QUEENSTOWN LAKES DISTRICT COUNCIL

Hearing of Submissions on Stage 3 Proposed District Plan

Report and Recommendations of Independent Commissioners

**Report 20.11: Remaining Variations Amending the PDP Chapters and other
General Matters**

Figure 1 - PDP Zoning and Rule Extent (Area from which the Variation proposes to remove the Rule is shown within the yellow outline)

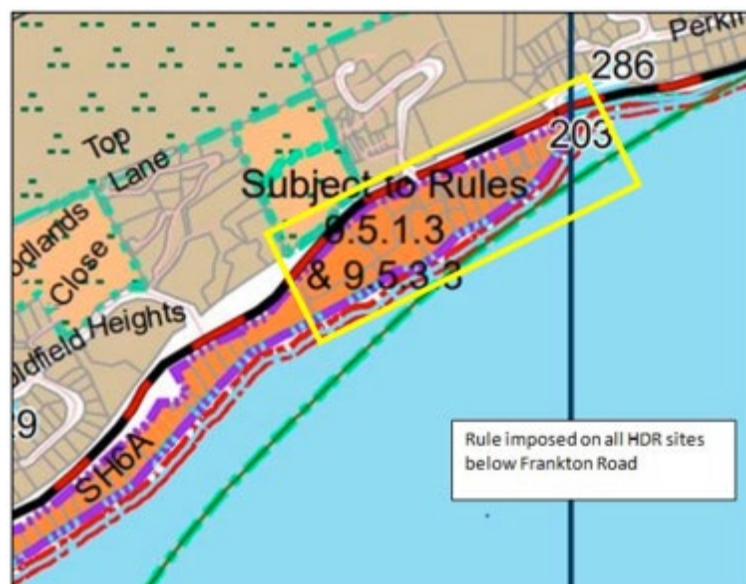
65. The Section 32A report identified that Rules 9.5.1.3 and 9.5.3.3 were erroneously applied to additional HDRZ properties below Frankton Road (shown within the yellow outline in the figure below)⁴⁶.

66. The Section 32 Report stated these rules were applied to to a greater extent than intended, incorporating 26 sites below Frankton Road where the underlying topography effectively means any development is unable to comply with either of the rules. Any redevelopment of the area to heights above the road level would effectively not be permitted, which is stated as not being the intention of the rule or the underlying zone. The notified variation sought to remove these sites from the PDP mapped area which is subject to Rule 9.5.1.3 and Rule 9.5.3.3 (demarcated as “specific rules apply/subject to Rules 9.5.1.3 and 9.5.3.3”).

76. Having visited the site, the Hearing Panel questioned Mr Matthee about the point at which the land along Frankton Road changes topography so that a 7m high building can be constructed without breaching the height control at the centerline of the road. The Panel had estimated this could be somewhere within the final variation site (the Sky City site), rather than right on the boundary between this site and Mr van Brandenburg's site. Mr Matthee agreed this point could be somewhere back into the final variation site, but in his view, it was not far enough back into that site to make it sensible to have two different height rules applied within the one site. He considered applying different height controls on one site would be impracticable for development of that site.

89. We accept the evidence of Mr Matthee that applying the ODP height control to the sites within the area of the variation would also unduly restrict development on the majority of the 26 sites in this area, allowing only one storey development for many sites and none for others. We agree with Mr Matthee that it would be contrary to the purpose of the HDRZ to apply the ODP Frankton Road height control in the area. It would add unnecessarily to the complexity of the PDP without corresponding benefits for protection of views to Lake Wakatipu from Frankton Road.
